**SUMMARY OF SITE INVESTIGATIONS  
AND RESPONSE TO THE EXPANDED  
SITE INVESTIGATION REPORT FOR  
LAND AND LAKES COMPANY  
NUMBER 3 FACILITY  
(122ND STREET LANDFILL)  
APPENDIX B VOLUME I**

RE: Land and Lakes #3  
#0316000034 - Cook County  
Addendum to Application for Significant Modification  
Log # 1995-060

The Addendum was prepared in response to Agency comments received by LALC. In order to facilitate the review of LALC's response to the Agency comments, this Addendum was formatted by presenting Agency comments in italics and LALC responses in standard text.

PRINTED 07-30-96

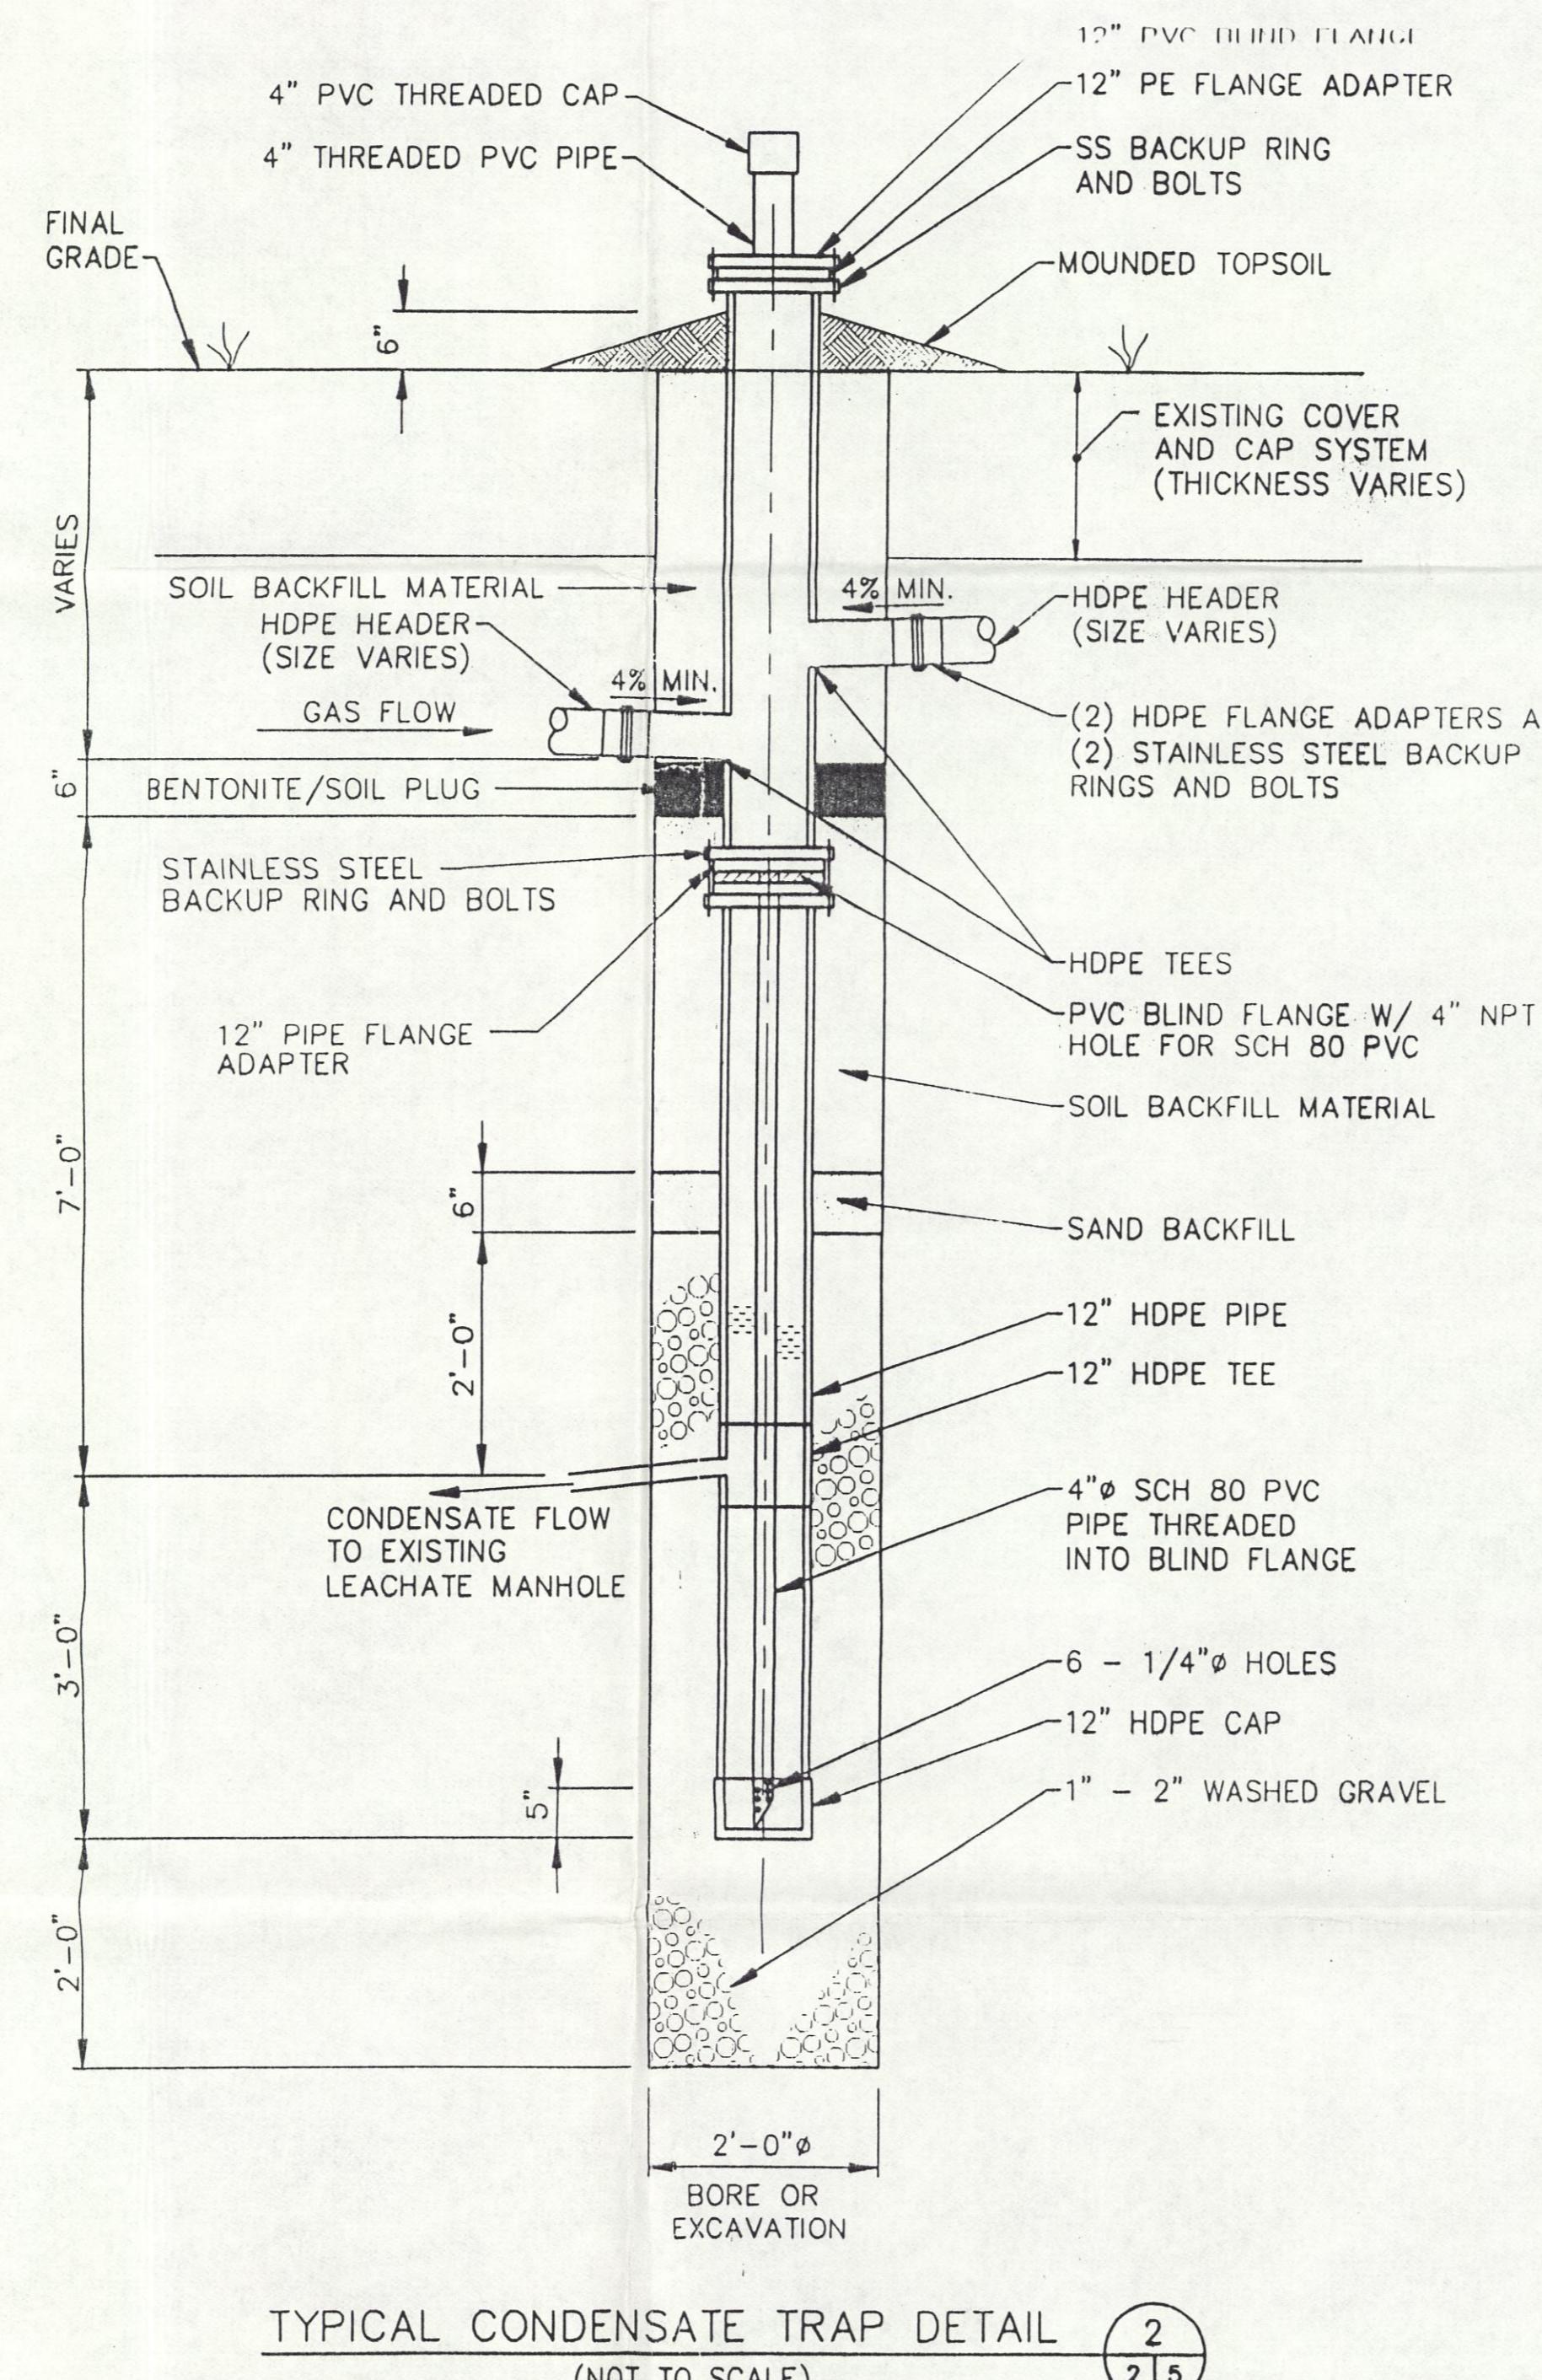
16. *The proposed condensate storage system, as shown on Drawing No. 4, does not appear to meet the requirements of 811.309(d) as required by 811.311(d)(8). Specifically, it does not seem to have secondary containment or a demonstration of adequate capacity.*

Secondary containment and an alarm system has now been integrated to the design, and will be installed for all condensate storage facilities located outside the limits of solid waste. Specifically, this pertains to the sump location located near the blower/flare station. See Drawing No. 5.

## FACTOR OF SAFETY AGAINST UPLIFT

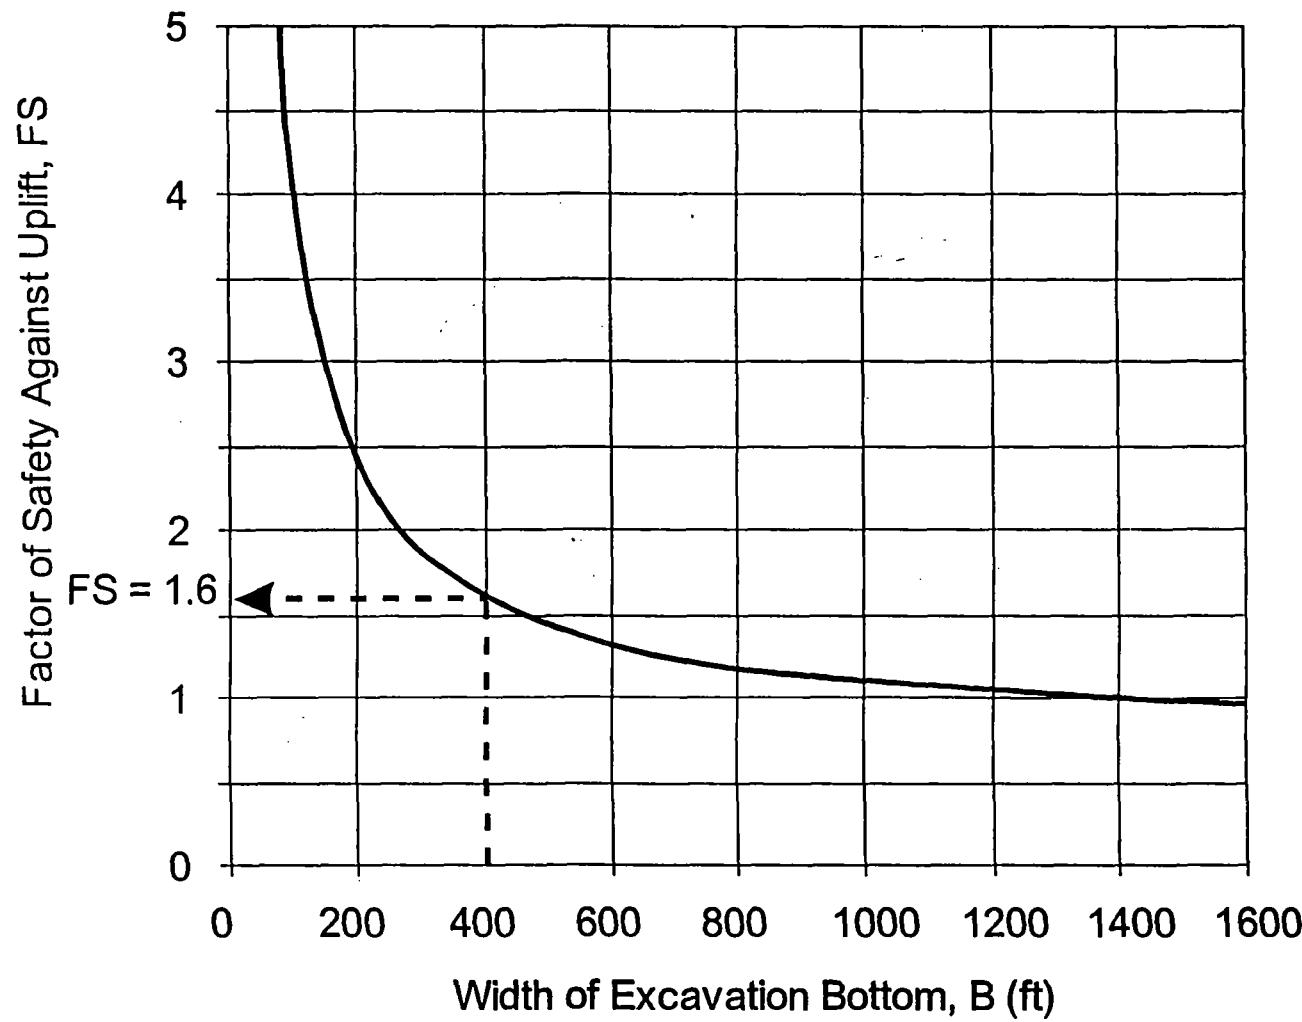
The uplift stability calculations presented by PEI are unrealistic. This is because the PEI uplift stability calculations do not consider the contribution of the strength of the soil.

A model of the uplift stability problem is illustrated in Figure 1 to this document. Figure 1a shows a plan view of an excavation with an excavation bottom width, B, and an excavation bottom length, L. A cross section of the excavation is shown in Figure 1b which defines the limits of the block of soil (i.e., the limits of the free body) considered in uplift stability calculations. Figure 1c defines the forces acting on the block of soil. The weight of the block of soil, W, and the soil shear forces, S, act downward and therefore resist uplift. The force, U, due to the water pressure in the bedrock aquifer, acts upward and therefore promotes uplift.

The results of the calculations are presented in Figure 2 to this document for a range of excavation bottom widths, B. As shown in Figure 2 to this document, the calculated factor of safety against uplift for Phase 1 ( $B = 400$  ft) is 1.6, which is satisfactory. Since Phase 1 is the critical phase, the calculated factor of safety
